**LEE C. FINE MEMORIAL AIRPORT
CITY OF OSAGE BEACH, MISSOURI**

ADDENDUM NO. 1

State Project No. 20-046B-1

FEBRUARY 11, 2021

20-046B-1
 Sheet 35 of 71
 Drawing: C-1403
 VOL. 1 of 1

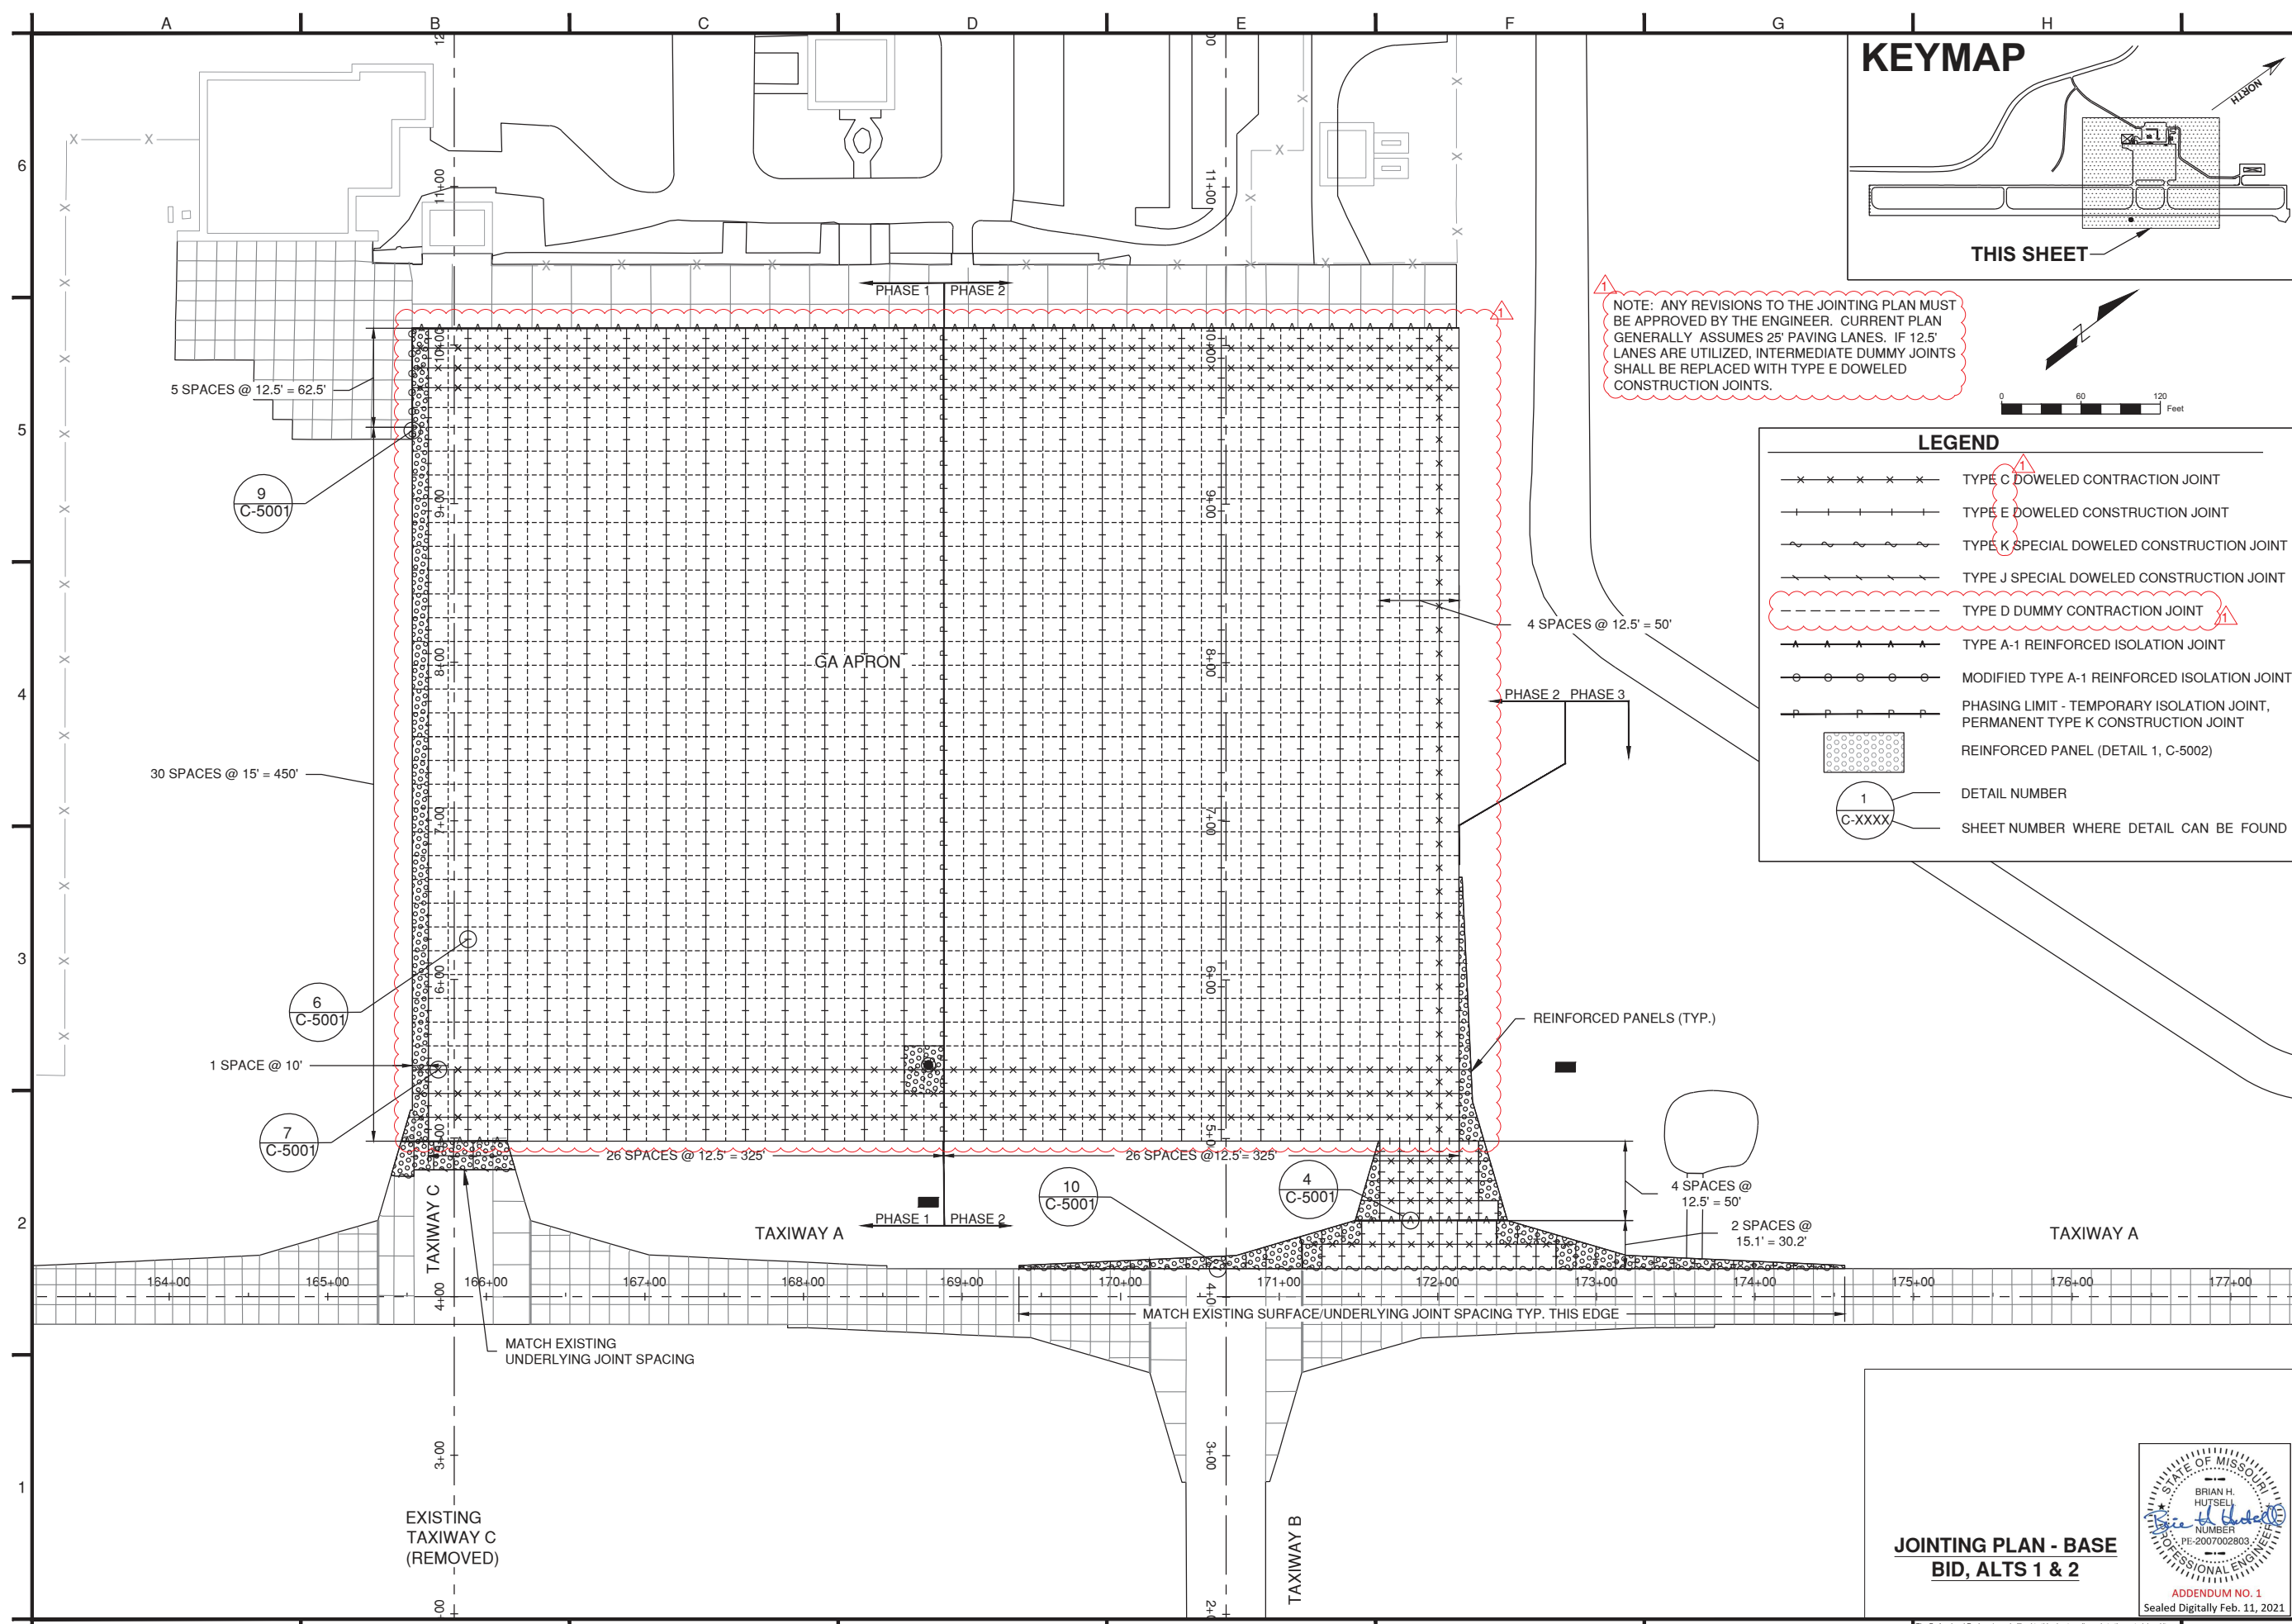
SHEET 35 of 71 – Jointing Plan – Base Bid, Alts 1 & 2

CLARIFICATION: Revised sheet reflects 25' paving lanes, and a reduction of transverse panel joint reinforcement and longitudinal joint reinforcement on interior panels. Outer panels will still be doweled or basketed, pending construction method. Note that if paved with 12.5' lanes, dummy joints would be replaced with doweled construction joints for load transfer. Legend revised to include dummy sawed joints, and other jointing types renamed for consistency.

NOTE: ANY REVISIONS TO THE JOINTING PLAN MUST BE APPROVED BY THE ENGINEER. CURRENT PLAN GENERALLY ASSUMES 25' PAVING LANES. IF 12.5' LANES ARE UTILIZED, INTERMEDIATE DUMMY JOINTS SHALL BE REPLACED WITH TYPE E DOWELED CONSTRUCTION JOINTS.

11 TYPE D DUMMY CONTRACTION JOINT
N.T.S. SYMBOL

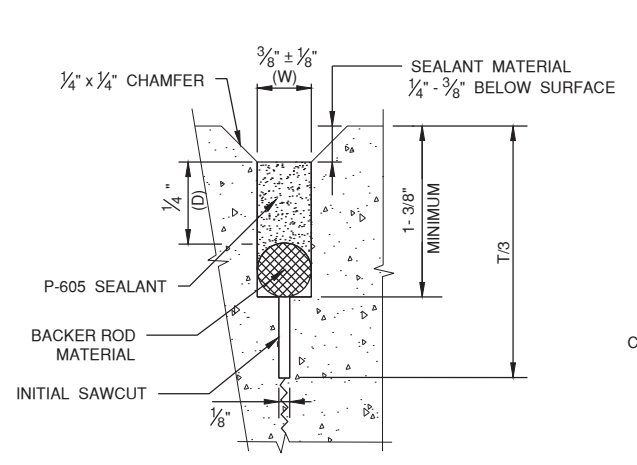
SHEET 45 of 71 – General Details Sheet 1 of 8

CLARIFICATION: Dummy joint detail added, other jointing types renamed for consistency.
